# Customer Notification

**B-CN-470-EN REV A**

**SUBJECT: TTS650 and TGS510 Operating Envelope Correction**

**Figure 1 – Operating Envelope, High SST: TTS650**

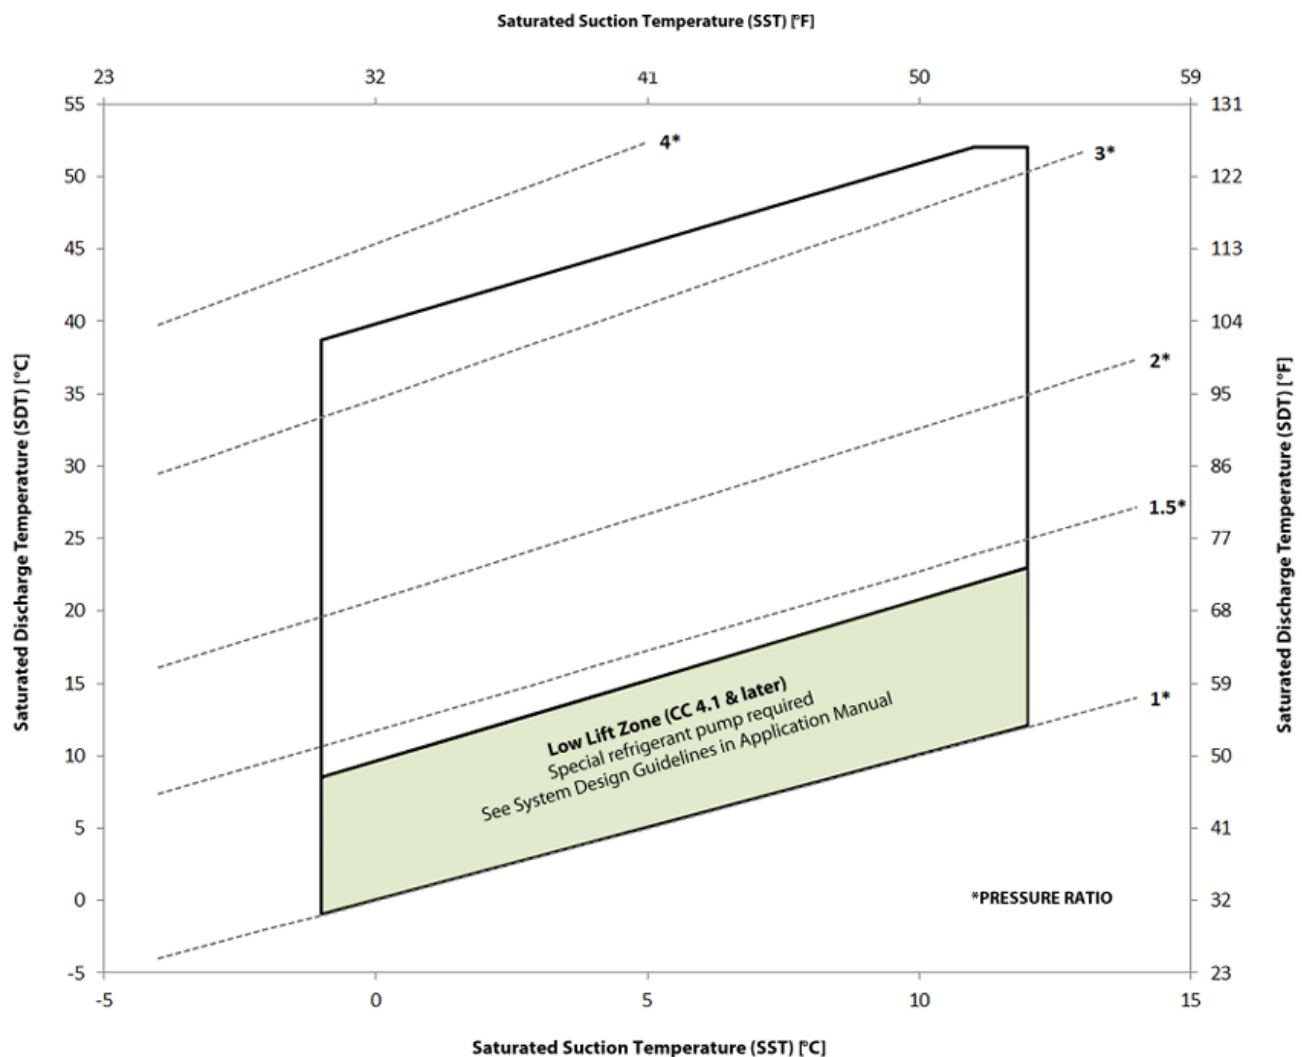
The TTS650 and TGS510 operating envelopes published in the M-AP-001-EN Applications and Installation Manual Revision U include incorrect scaling on the right-hand axis (Saturated Discharge Temperature (SDT) [F°]). The operating envelopes can be found on pages 65 and 67 of the manual.

The Celsius temperature scale shown on the graph is correct; however, the corresponding Fahrenheit temperature scale was converted incorrectly.

### Incorrect Fahrenheit Scale

- 41°F to 131°F

### Correct Fahrenheit Scale

- 41°F to 158°F

Please reference the corrected Fahrenheit scale of **41°F to 158°F** when reviewing the TTS650 and TGS510 High SST Operating Envelopes.
